PHILADELPHIA ELECTRIC COMPANY

Subject: Limerick Generating Station, Units 1 and 2
Structural Steel Fire Resistance

The attachments provide the information requested in Reference (2) and documented in Reference (3), to support the program we presented to close out SER Open Item #14, Structural Steel Protection.

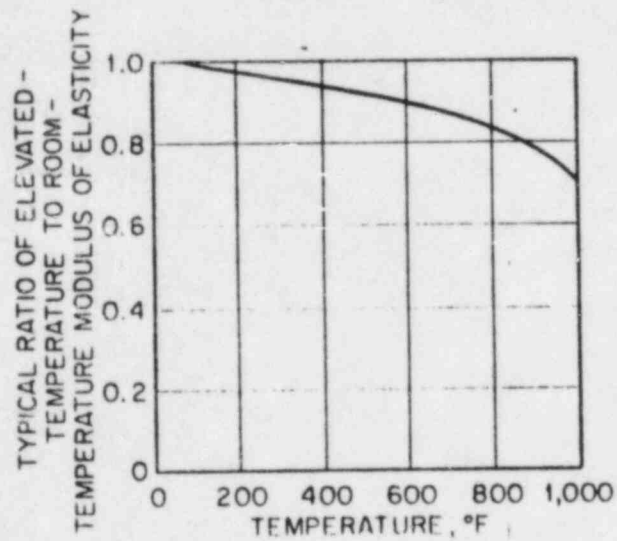
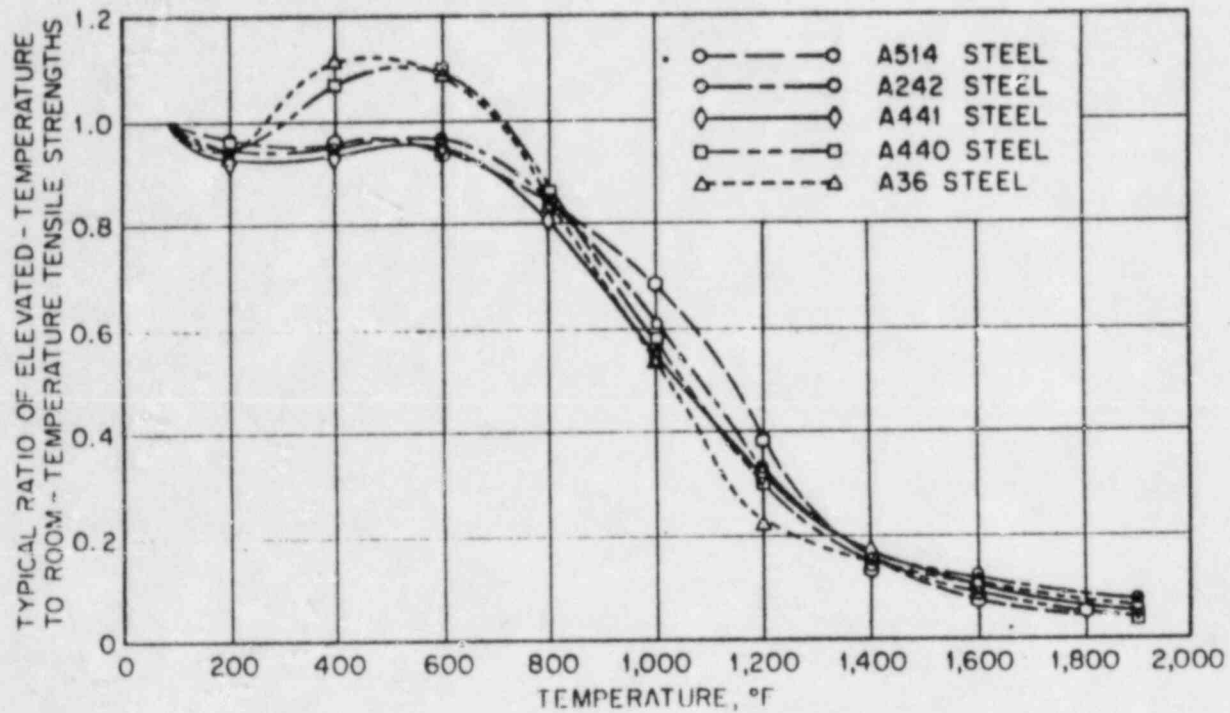
The curves contained in Attachment I were published by the U. S. Steel Corporation and illustrate the effect of temperature on yield strength, tensile strength and modulus of elasticity. Similar curves published by the American Iron and Steel Institute (AISI) are contained in Attachment II. The structural steel used at Limerick conforms to ASTM Specification A36.

The steel behavior predicted by these curves is based on tension tests of small uniformly heated test specimens. While the curves provide an indication of the effect of temperature on the properties of steel, they are not considered to accurately represent the totally different stress condition existing in flexural members that are both end restrained and constructed compositely with the concrete slab. In the reference material submitted with the structural steel methodology, the behavior of structural members subjected to elevated temperatures is discussed in greater detail.
